Sirona R44/04

**Changes Q4 2017**

## Modification of the buckle storage

## Manual change 1/2

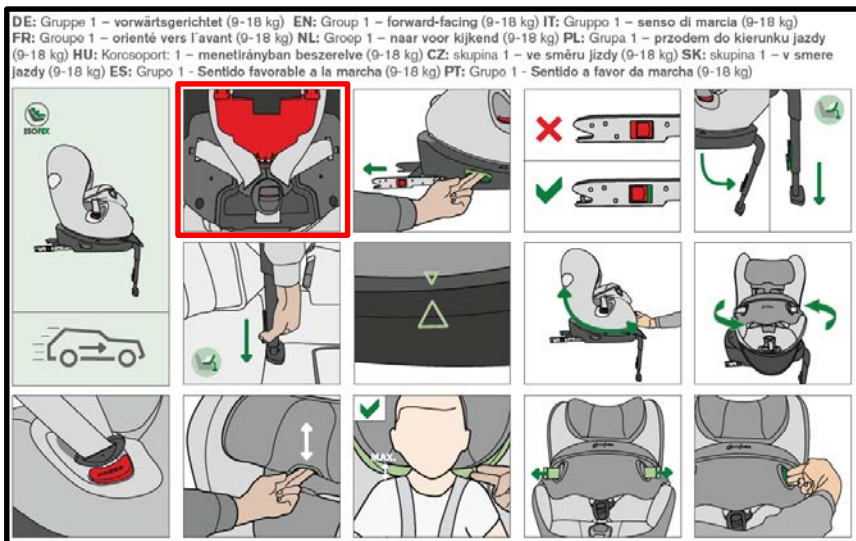
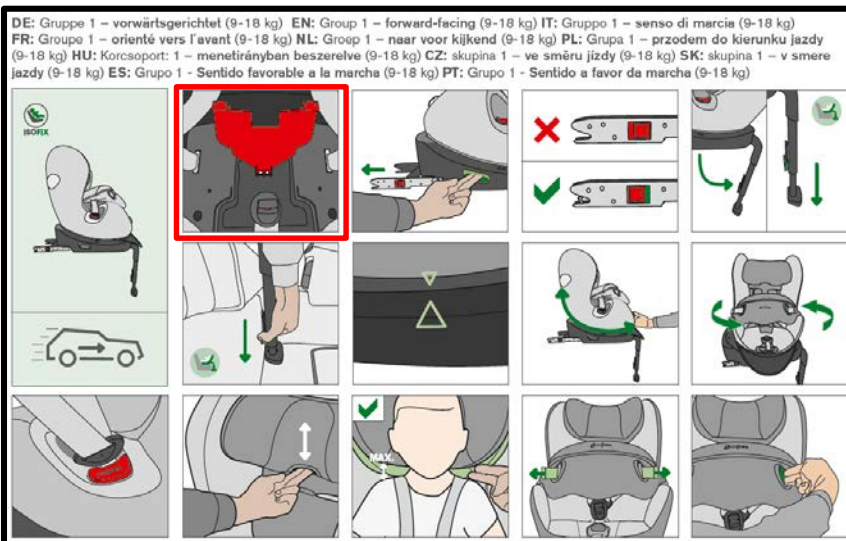
### Sirona today (p. 3)

### Sirona new (p. 3)

change

## Manual change2/2

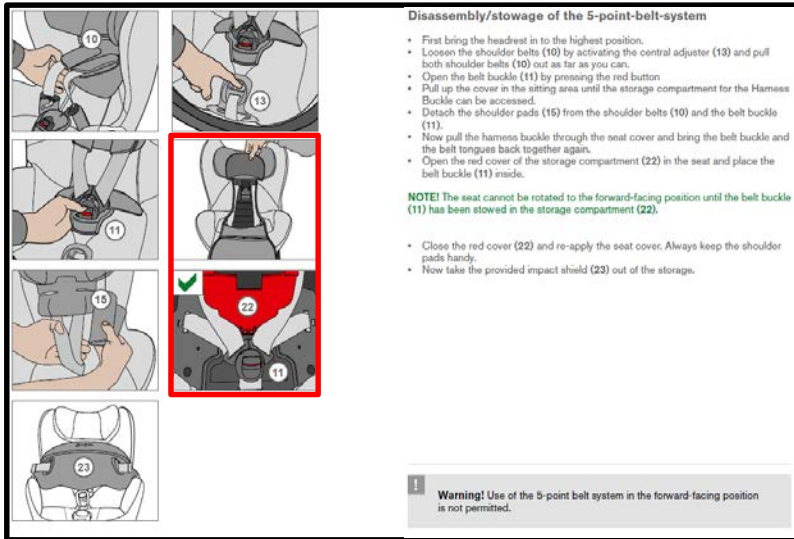
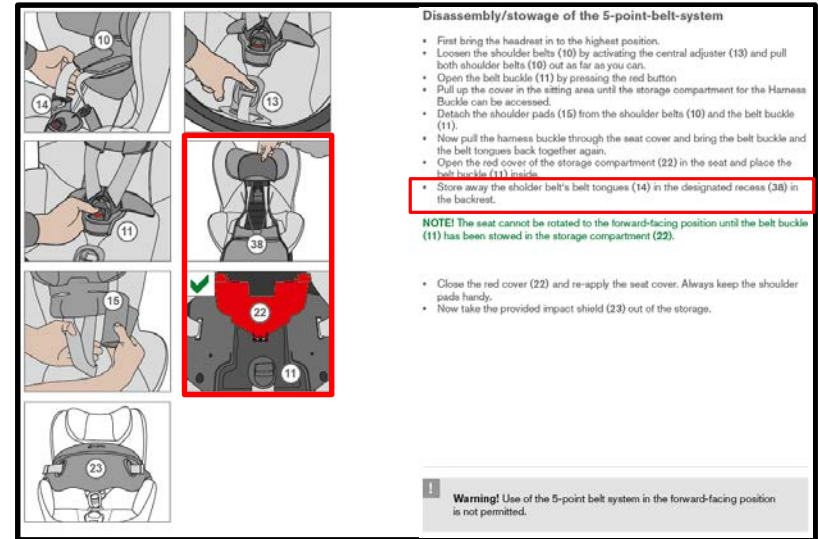
### Sirona today (p. 31)

**Disassembly/storage of the 5-point-belt-system**

- First bring the headrest in to the highest position.
- Loosen the shoulder belts (10) by activating the central adjuster (13) and pull both shoulder belts (10) out as far as you can.
- Open the belt buckle (11) by pressing the red button
- Pull up the cover in the sitting area until the storage compartment for the Harness Buckle can be accessed.
- Detach the shoulder pads (15) from the shoulder belts (10) and the belt buckle (11).
- Now pull the harness buckle through the seat cover and bring the belt buckle and the belt tongues back together again.
- Open the red cover of the storage compartment (22) in the seat and place the belt buckle (11) inside.

### Sirona new (p. 31)

**Disassembly/storage of the 5-point-belt-system**

- First bring the headrest in to the highest position.
- Loosen the shoulder belts (10) by activating the central adjuster (13) and pull both shoulder belts (10) out as far as you can.
- Open the belt buckle (11) by pressing the red button
- Pull up the cover in the sitting area until the storage compartment for the Harness Buckle can be accessed.
- Detach the shoulder pads (15) from the shoulder belts (10) and the belt buckle (11).
- Now pull the harness buckle through the seat cover and bring the belt buckle and the belt tongues back together again.
- Open the red cover of the storage compartment (22) in the seat and place the belt buckle (11) inside.
- Store away the shoulder belt's belt tongues (14) in the designated recess (38) in the backrest.

## New label underneath the cover

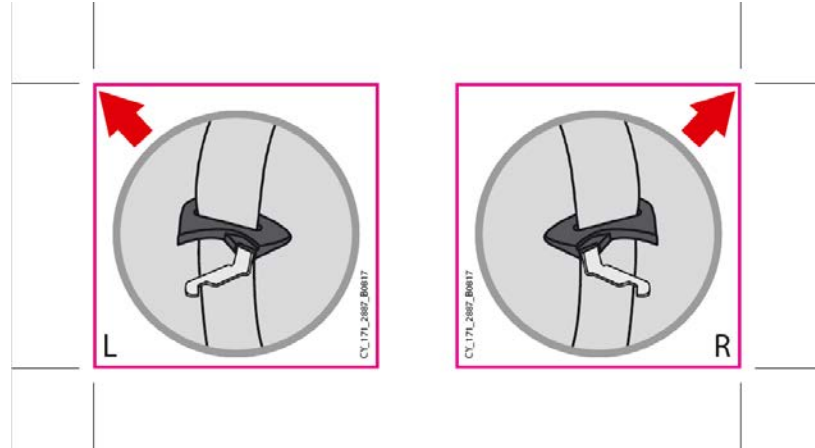
2 new labels

Positions of the label
